# Access Compliance Report

## Public Rights-of-Way (Curb Ramps)

Intersection ID: 21109	Main Street: OAKHAVEN_DR	Cross Street: SANDY_PORTER_RD	Location: SW
ADA ID: 80FB7FBA9527	Ramp Type: Directional1	Initial Pass/Fail: Pass	Overall Compliance: No
		Severity Score: 2.5

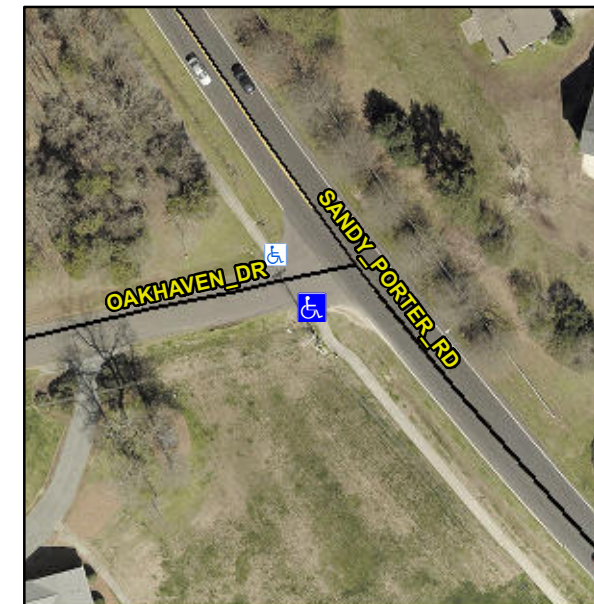
PROW/ADA:

**R305.1.4**

Possible Solutions:

**Remove & Replace Detectable  
Warning System.**
